## **NOTICE OF MEETING**

The City of Lake Elmo  
Planning Commission will conduct a meeting on  
**Monday October 22, 2018**  
**at 7:00 p.m.**  
**AGENDA**

STAFF REPORT

**TO:** Planning Commission  
**FROM:** Ben Prchal, City Planner  
**AGENDA ITEM:** Shoreland Variance Request to exceed the allowed impervious surface within the shoreland district as well as exceed the allowed maximum driveway width – 7962 Hill Trail.

**BURNS SITE PLAN**

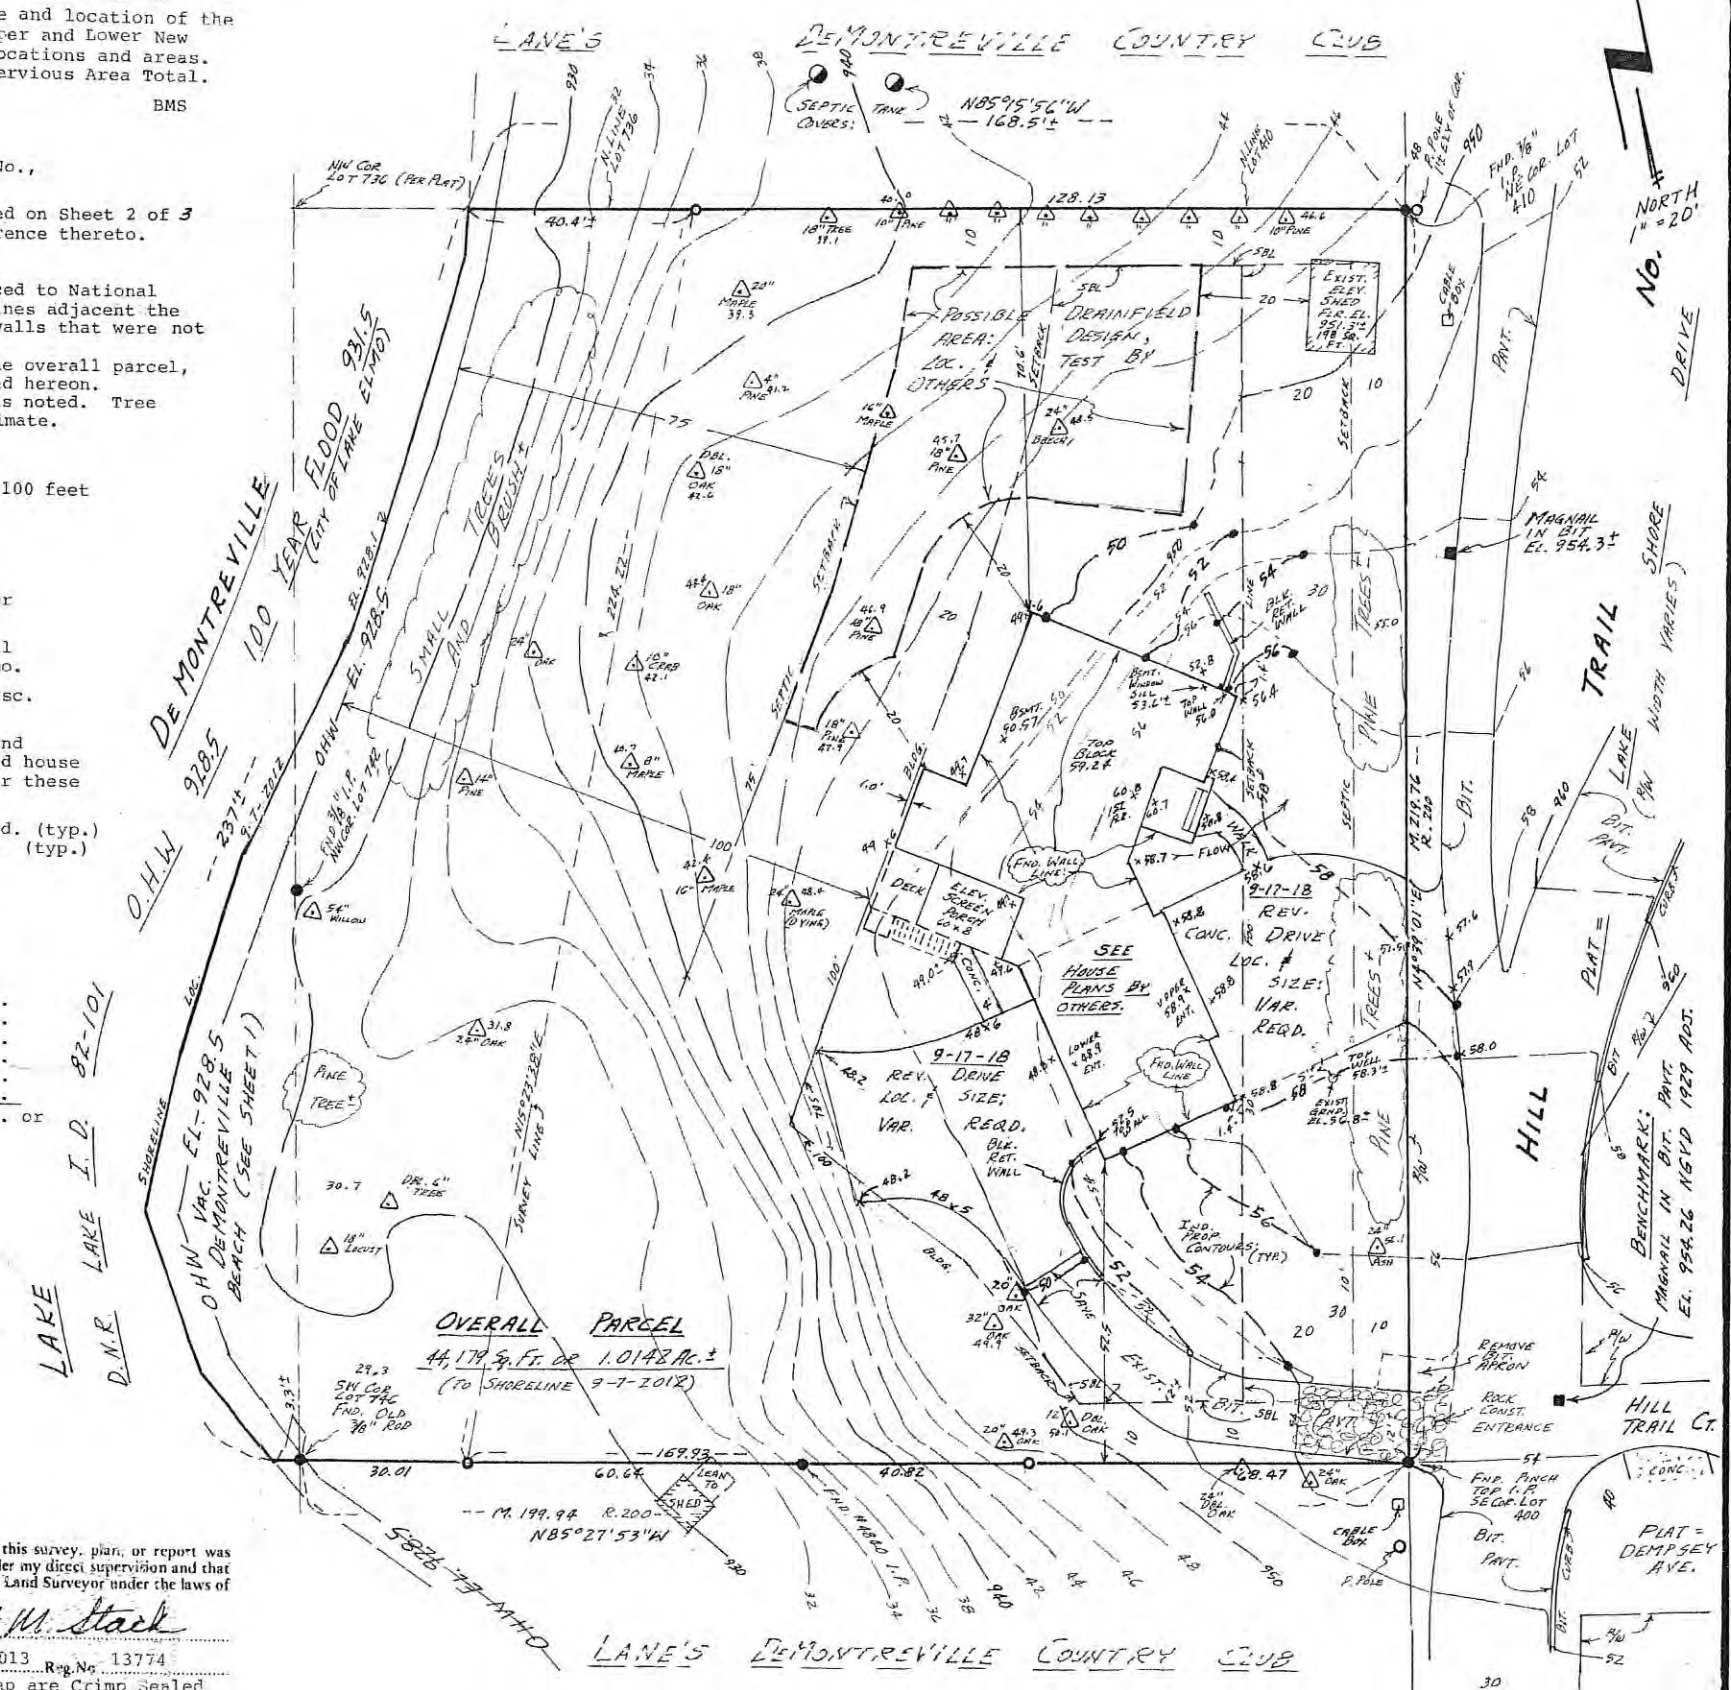
- The previously approved plans for the site allowed the applicant a main driveway width of 18ft. as well as the 12 ft. for the second smaller driveway. This also exceeds the allowed limit of 26ft. by 4 ft. The current proposal would exceed the limit by 16 ft.

Code Location	Code Setbacks	Proposed Setbacks
Maximum Driveway Width 93.26 A. (b)	26 ft.*(combined width)	30 ft. (Main Driveway – proposing change)
		12ft. +apron(Second Driveway – no change)
Lot width 93.26 A. 1. (c)	150 ft.	219.76 ft.
Distance of Curb Radii	40 ft.	44 ft.
Impervious Surface 154.800 table 17-3	15% (Un-sewered Properties)	16.5%

SHEET 1 ONLY:  
9-17-18 Revision Note:

Revised size and location of the Proposed Upper and Lower New Drive way locations and areas.  
Revised Impervious Area Total.  
BMS

Staff recommends that the Planning Commission recommend approval of the variance request in regards to the expanded driveway width. Staff does not feel they can support the difficulty of limited impervious surface as it seems to be caused by the home owner. Where the ROW, topography/elevations associated with the roadway are not. If the commission feels there are grounds to support the increase impervious surface, new findings may be presented and reworked for City Council.

- 1) The Applicant shall secure any required permits and plan approvals from the City and other applicable jurisdictions.
- 2) The grading of the driveway shall be required to drain, primarily to private yard areas, either north of south of the driveway. The extent of paved surface that drains directly to the street should be minimized since there is no existing drainage system within the street.
- 3) It shall be a condition of approval that all outstanding items related to City of Lake Elmo New Construction Permit 2013-00393 be completed and approved before the release of any permits associated with this variance

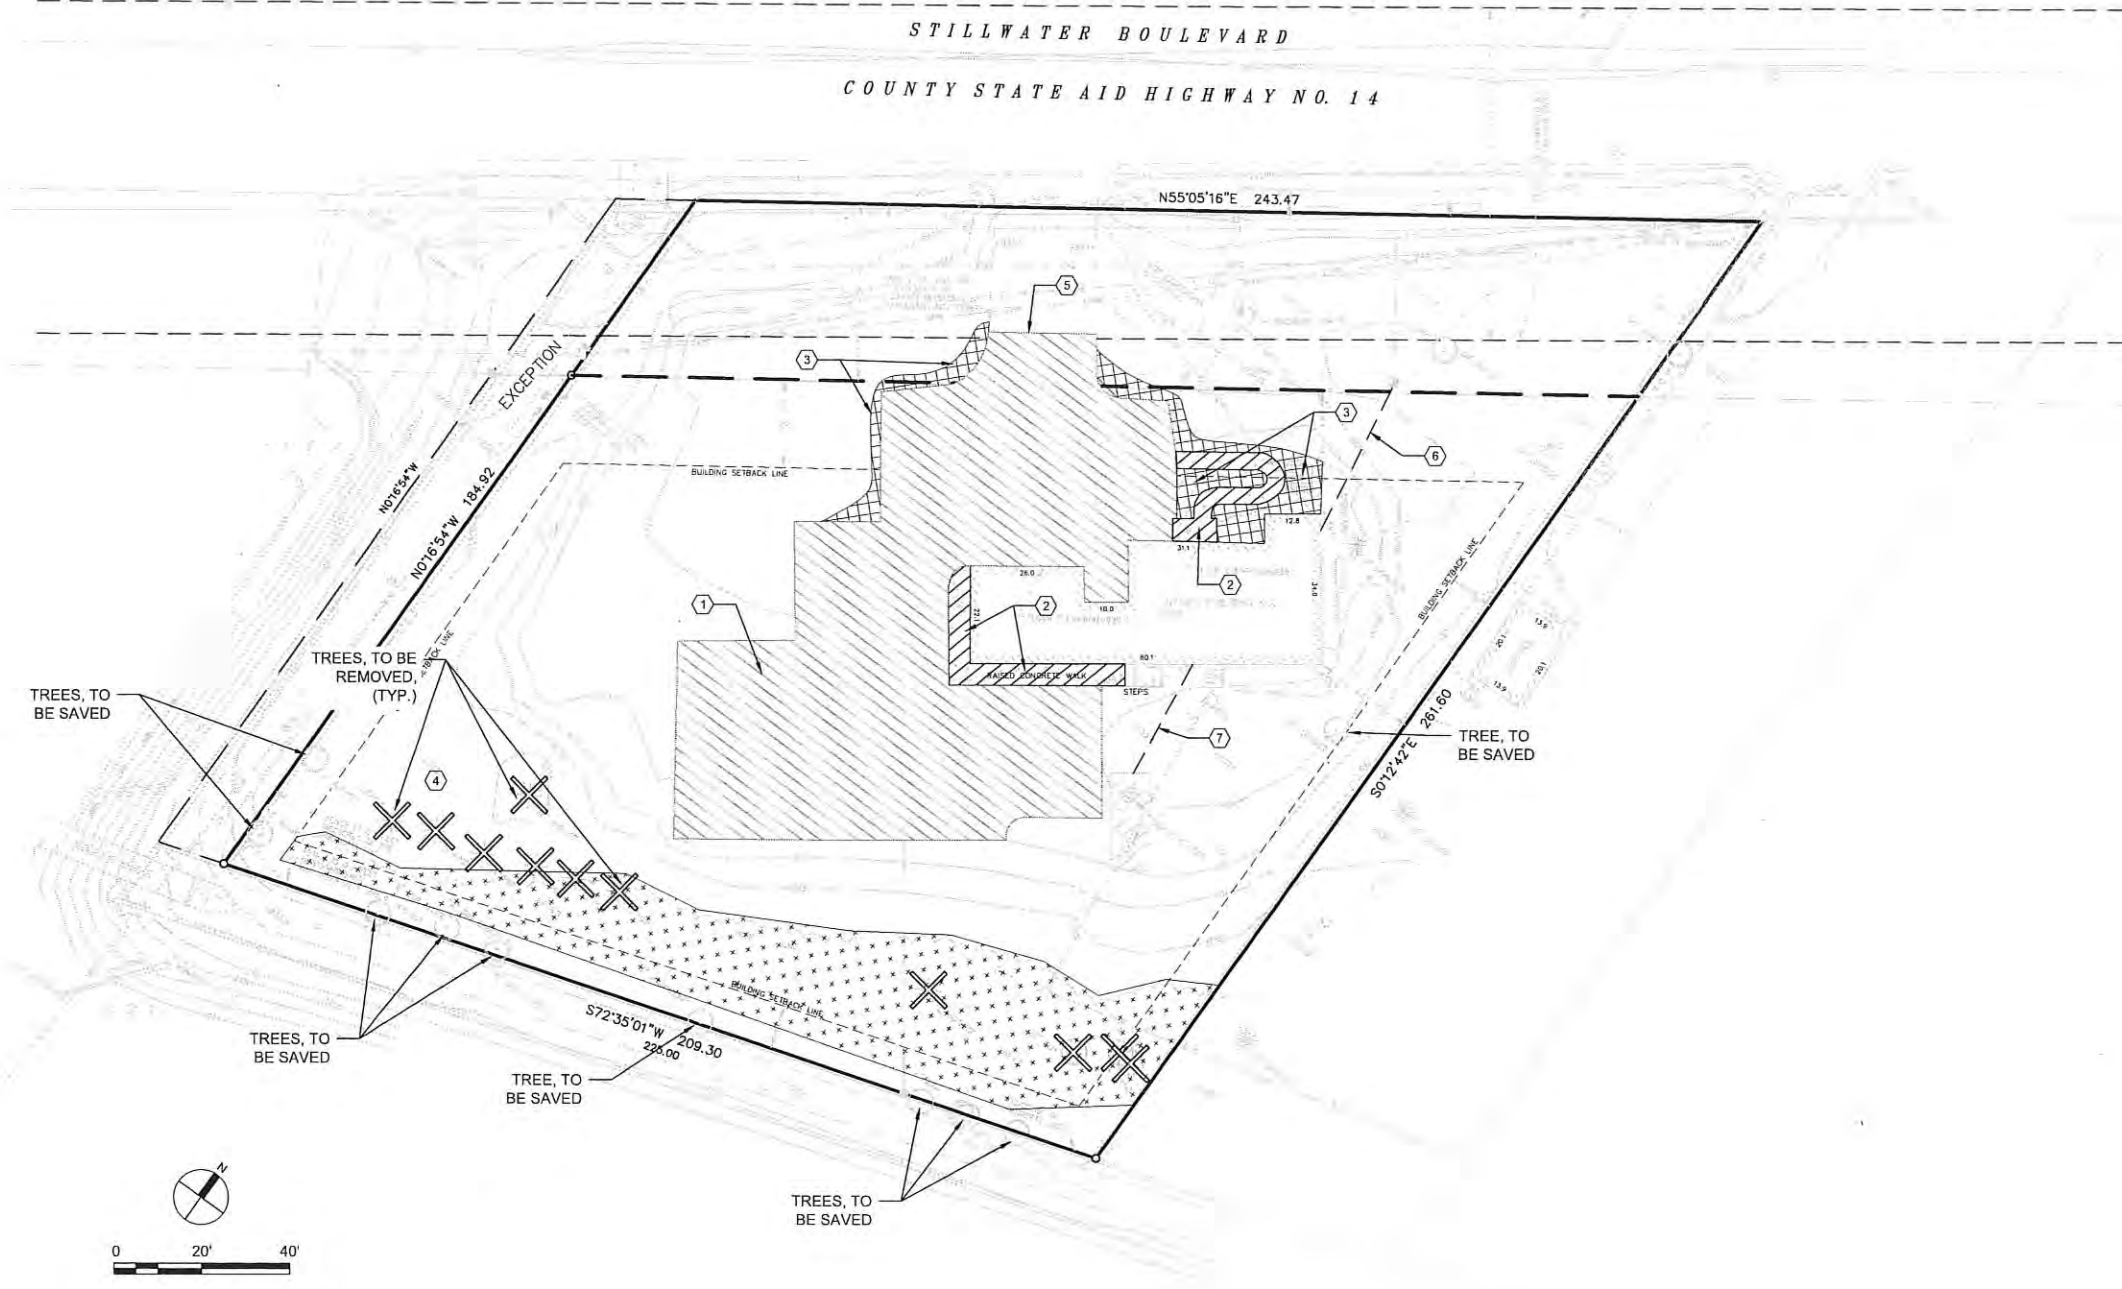
Based on review of the Existing Conditions and Removal Plan, sheet C1, the estimated tree inventory and mitigation calculations are:

2. Tree replacement calculations need to be provided confirming what was deduced from the Existing Conditions and Removals Plan, sheet C1 and to confirm the quantity and type of trees that need to be provided for mitigation of the removals in excess of the 30% removal limit for each category; hardwood, evergreen/deciduous, and common trees.

1 LANDSCAPE PLAN  
SCALE: 1" = 20'

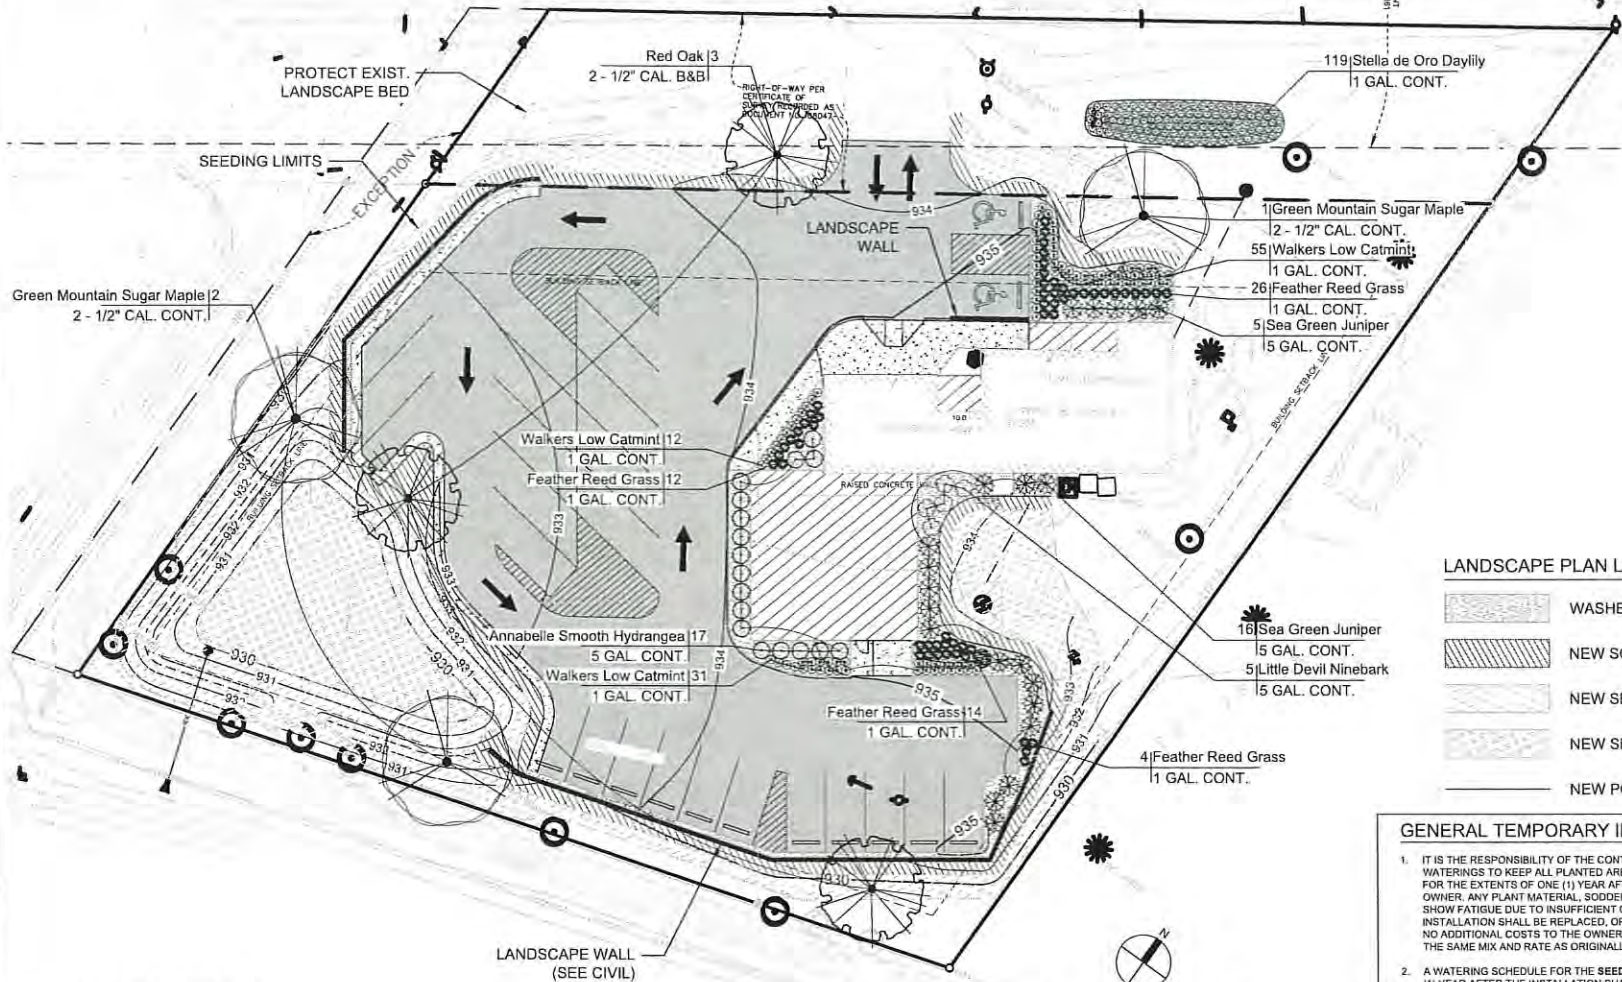
**Landscape Plans.** The applicant has submitted landscape plans showing the proposed landscaping for the property. After reviewing the site they will need to provide more trees than what is shown on the plans. After applying the updated environmental performance code, further information to confirm staff review is needed.

- A tree preservation plan shall be required to confirm the number of trees needed.
- The required number of trees will need to be increased to meet code requirements. It will be a condition of approval that the applicant receive approved landscape plans.

TYPICAL TOWNHOME LOT DETAIL

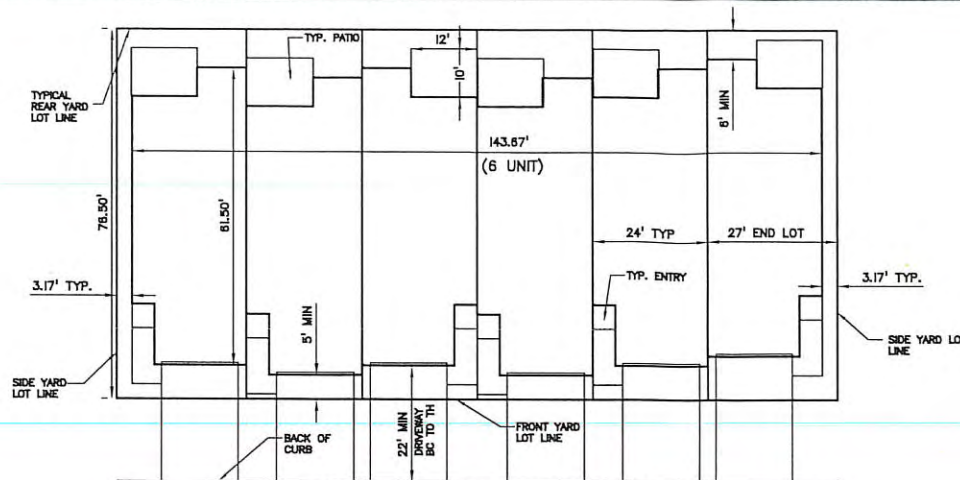
- *As noted on Sheet 1 of 3 of the Applicant's submittal, the "Typical Townhome Lot Detail" identifies a minimum of 24-feet of frontage for interior units.*

On the attached Applicant's Sketch Plan submittal, sheet 1 of 3 identifies a conceptual layout of the units overlaid on an aerial, and identifies a "Typical Townhome Lot Detail." Staff notes that the dimensions shown on the Lot Detail do not meet some of the ordinance requirements, and also are inconsistent with the information shown on the Sketch Plan. Additionally, Staff notes that the Typical Townhome Lot Detail shows interior lots with a lot area of 1,836 SF, and end units with approximately 2,065 SF. If each unit is platted with an individual lot then the proposed lots do not meet the ordinance, unless open spaces can be averaged into the analysis. However, if individual lots are not proposed as shown on the conceptual layout of the units, then the City's ordinance allows for the lot area to be calculated based on density. If this calculation is performed, then the lot area would average approximately 6,310 SF and would meet the City's ordinance. This should be clarified by the Applicant at the time of preliminary plat, and regardless of the approach taken, the proposed configuration must meet the City's lot and bulk standards.
